<b>HYUNDAI</b> <b>Technical Service Bulletin</b>	<b>GROUP</b> <b>RECALL</b>	<b>NUMBER</b> <b>24-01-082H</b>
	<b>DATE</b> <b>NOVEMBER 2024</b>	<b>MODEL(S)</b> <b>SANTA FE (MX5A)</b> <b>SANTA FE HYBRID</b> <b>(MX5A HEV)</b>
<b>SUBJECT:</b> SUNROOF AND REAR SUNROOF SHADE SWITCH KNOBS REPLACEMENT (RECALL 270)

**Description:** Certain 2024 Santa Fe (MX5A) and Santa Fe Hybrid (MX5A HEV) vehicles equipped with an Overhead Console Sunshade Switch may not be fully recessed, increasing the risk of inadvertent sunshade activation. As such, the subject vehicles do not meet the test requirements of Federal Motor Vehicle Safety Standard No. 118 “Power-Operated Window, Partition and Roof Panel Systems.” Inadvertent sunshade activation could increase the risk of minor pinch point injury occurring from unexpected closure of the fabric sunshade. Follow the procedure outlined in the TSB to replace the sunroof and rear sunroof shade switch knobs.

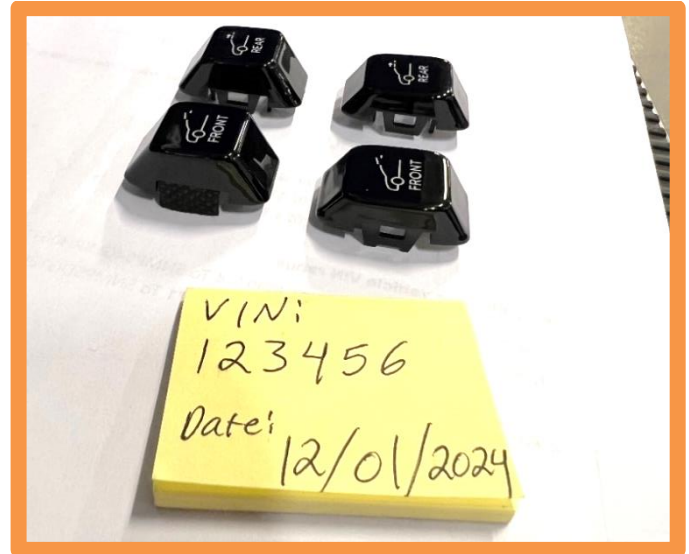
Using STUI, take a photo of the new switch knobs next to the old switch knobs with the last 6 digits of the VIN and the date of repair on a piece of paper.

If the overhead console assembly was replaced due to damage instead, take a photo of the new overhead console installed with the last 6 digits of the VIN and the date of repair on a piece of paper.
